RESOLUTION NO. 17-46

**A RESOLUTION APPROVING THE SITE PLAN FOR THE FIRST PHASE OF
SKIPPER BUDS**

SKIPPER BUDS - SEQUOIT HARBOR
STORAGE BUILDINGS AND STORMWATER MANAGEMENT
ANTIOCH, ILLINOIS

REPORT TO: VILLAGE PRESIDENT and BOARD OF TRUSTEES
FROM: MICHAEL S. GARRIGAN, AICP, CNU-A, Community Development Director
DATE: August 8, 2017
SUBJECT: REPORT TO PZB

SITE AND UTILITY PLAN

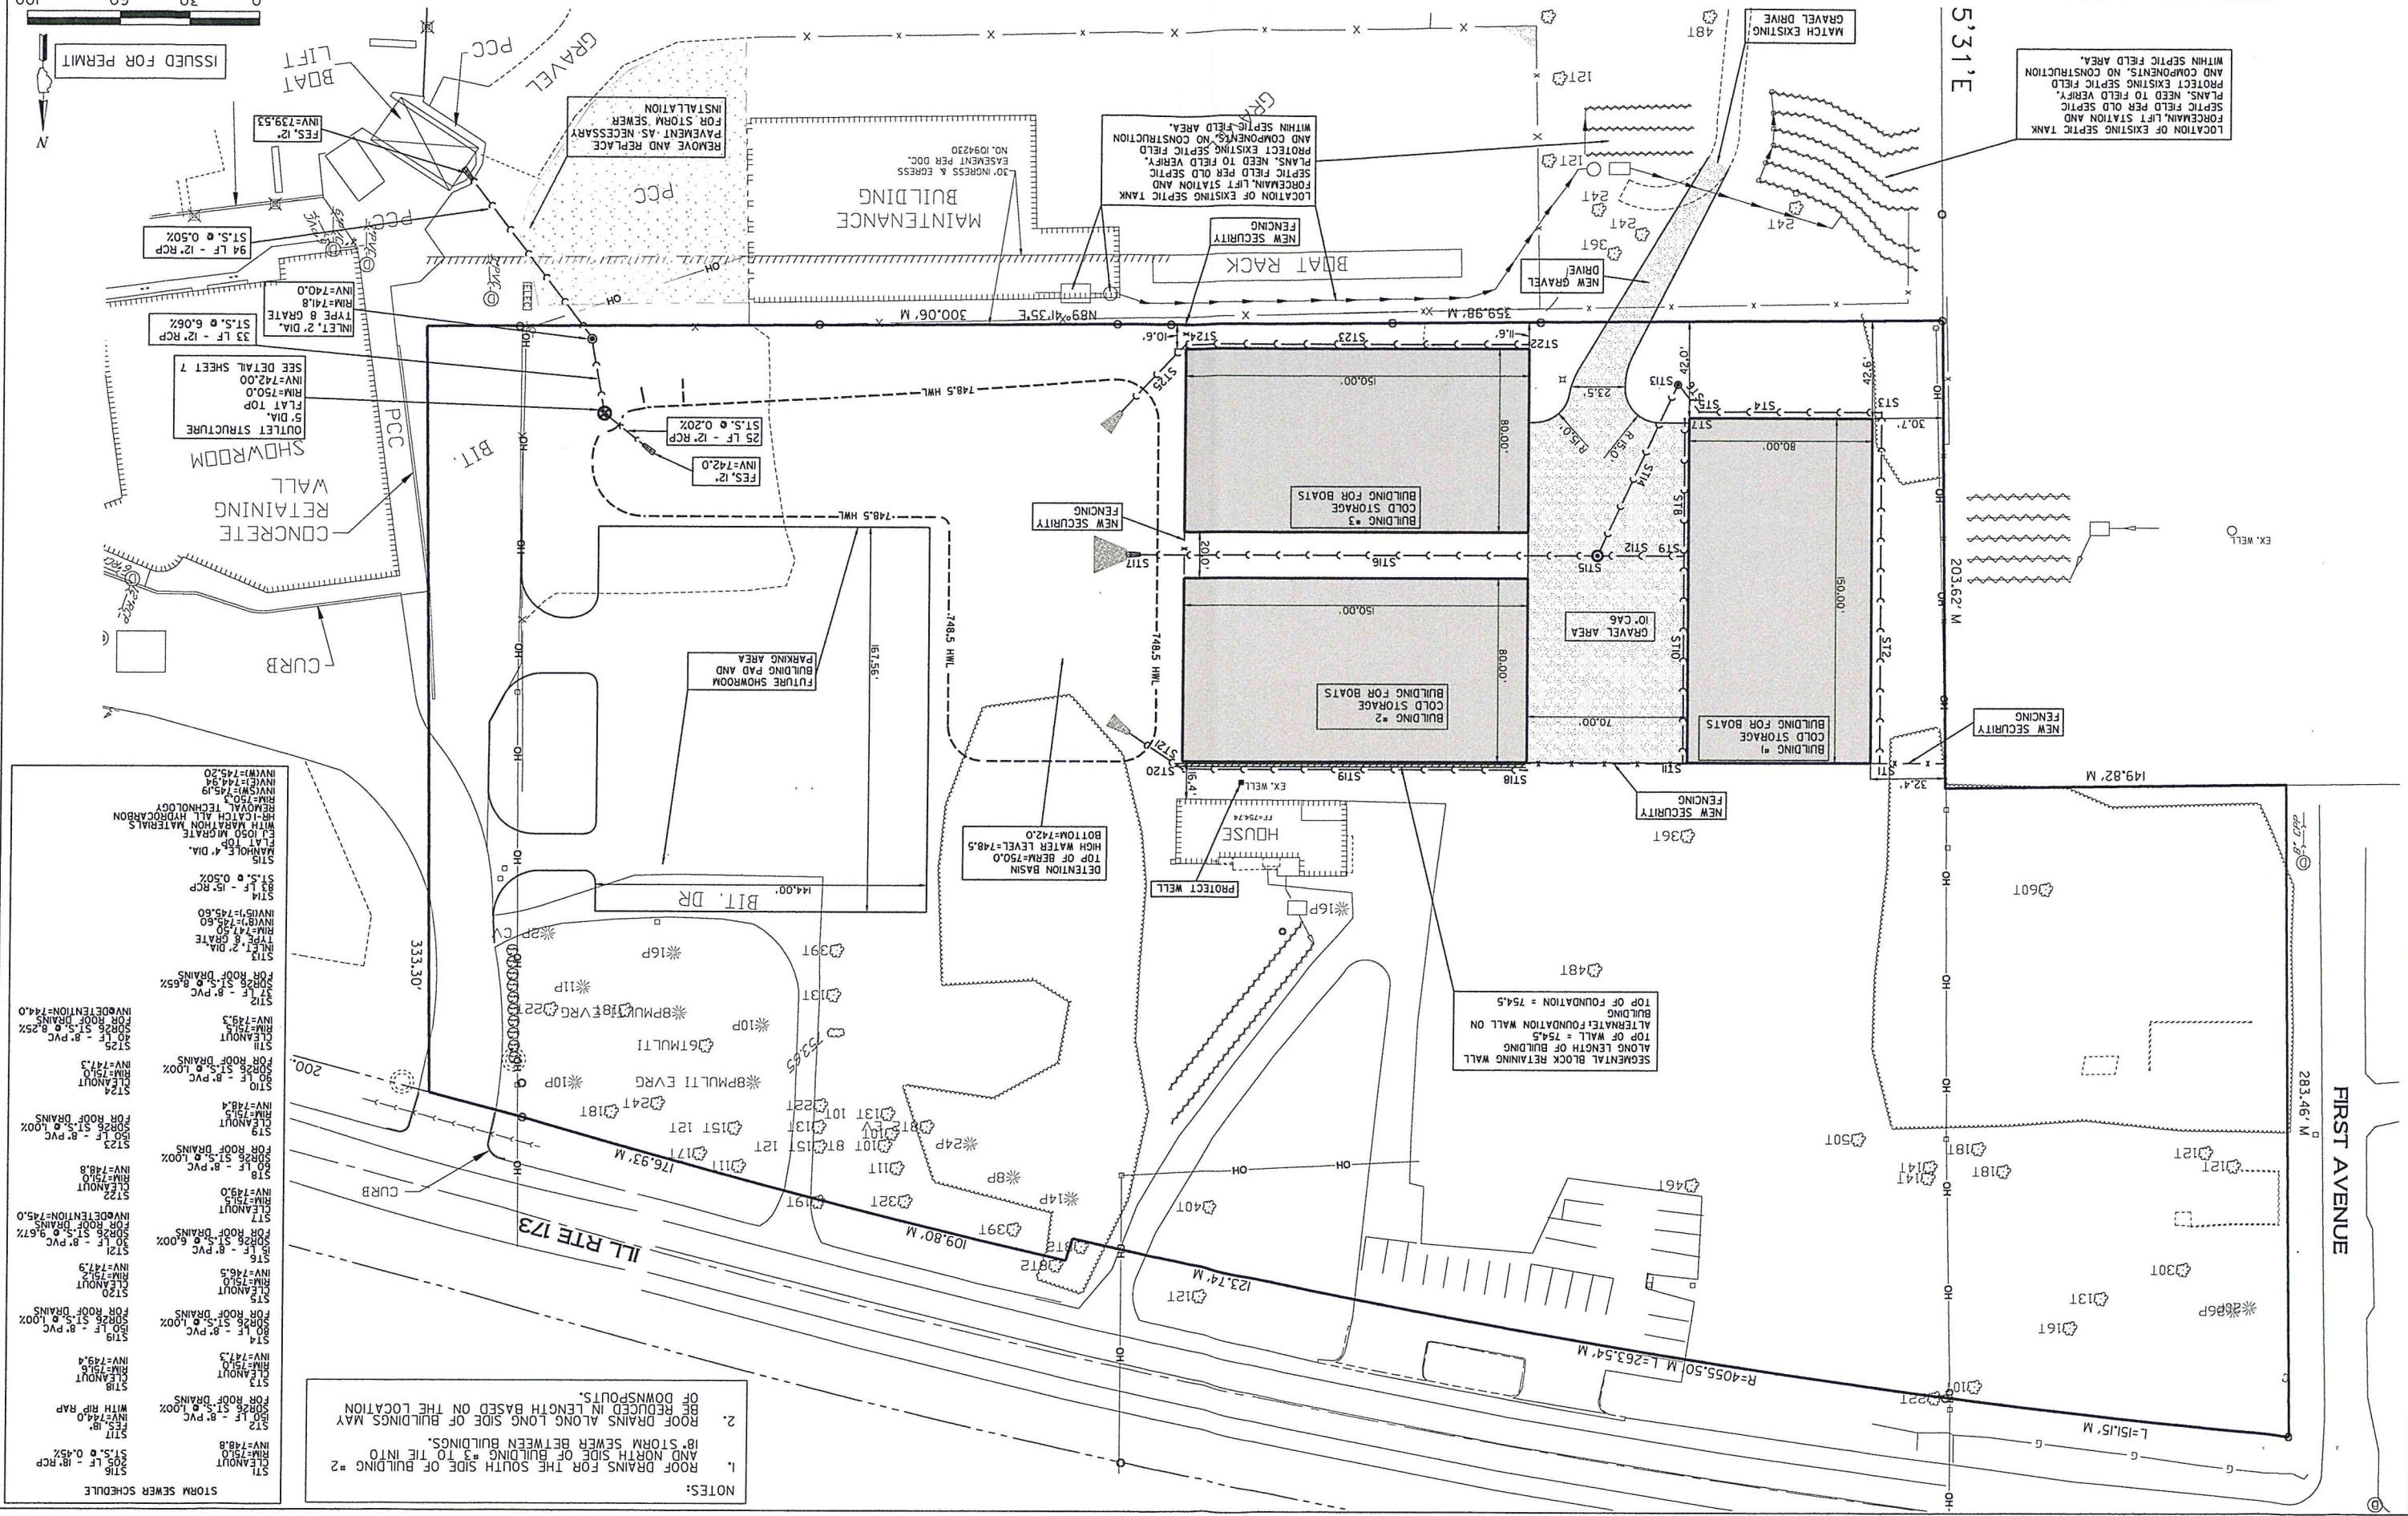
The applicant is proposing to construct a stormwater pond to the east of the proposed storage buildings along with a Best Management Practice design elements including a series of drainage swales adjacent to the proposed buildings.

- The applicant should identify the natural plantings that will be introduced to these drainage swales which will provide a treatment train consistent with Best Management Practices. In view of the sites proximity to Lake Marie, the introduction of BMP's is appropriate for this site.

- 1. Compliance with the requirements of the Village Engineer.***
- 2. Compliance with the requirements of the Antioch Fire Protection District.***
- 3. Any lighting fixture wall pack shall comply with Village Ordinance as it relates to being set at a ninety degree angle towards the ground.***
